VIRGINIA ELECTRIC AND POWER COMPANY
SURRY POWER STATION UNITS 1 AND 2
EVALUATION OF PRELIMINARY WHITE FINDING AND ASSOCIATED NRC RISK
ANALYSIS CONTAINED IN NRC INSPECTION REPORT NOS. 05000280/2003008
AND 05000281/2003008

**Evaluation of an NRC's Significance Determination Process Phase 3 Analysis for
an Appendix R Fire in the Unit 1 (or Unit 2) Emergency Switchgear Room**

Surry Power Station Units 1 and 2

Figure 1
 Surry RCP Seal LOCA Model Reflecting Floating Ring Seals
 (50% Probability Floating Ring Seal Failure)

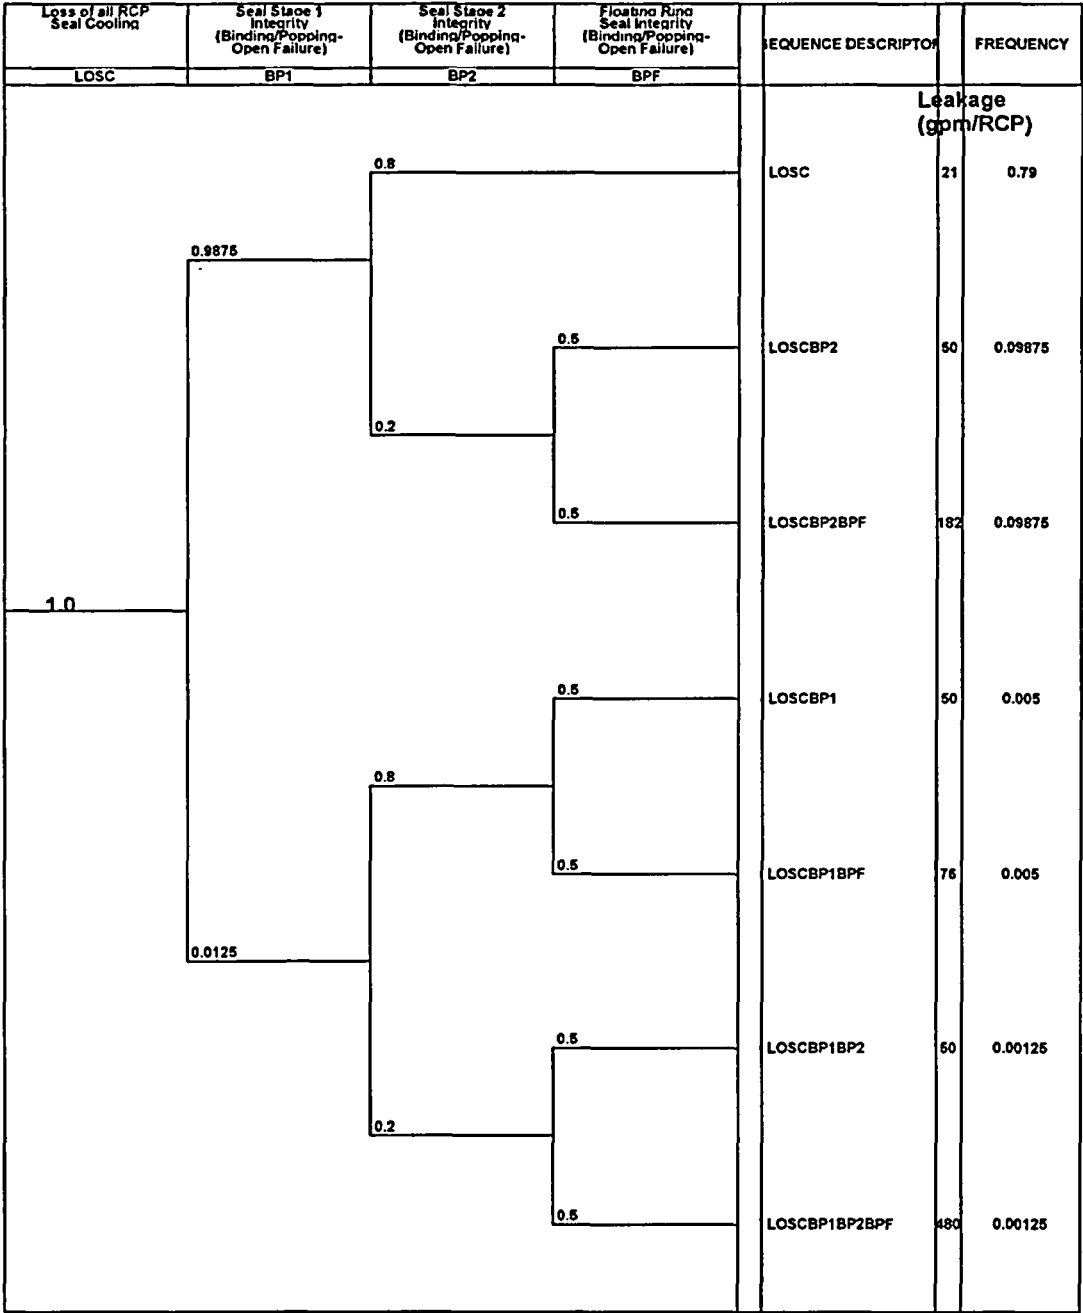
The RCP seal LOCA event tree in WCAP-15603 Rev. 1-A can be modified to consider credit for the RCP floating ring seals. Credit for the floating ring seals is assumed to range from 0.1 to 0.5 based on the following considerations:

The conditional likelihood of RCP seal leakage events beyond 50 gpm per RCP was calculated from the modified RCP seal LOCA model event tree in Figure 1 for various floating ring seal failure probabilities between 0.1 and 0.5. These results were utilized in the sensitivity cases described below.

Assumed RCP Floating Ring Seal Failure Probability	Conditional RCP Seal Leakage Rate Greater than Charging Makeup Capability (>50 gpm/RCP) ¹
0.1	0.021
0.2	0.042
0.3	0.063
0.5	0.10
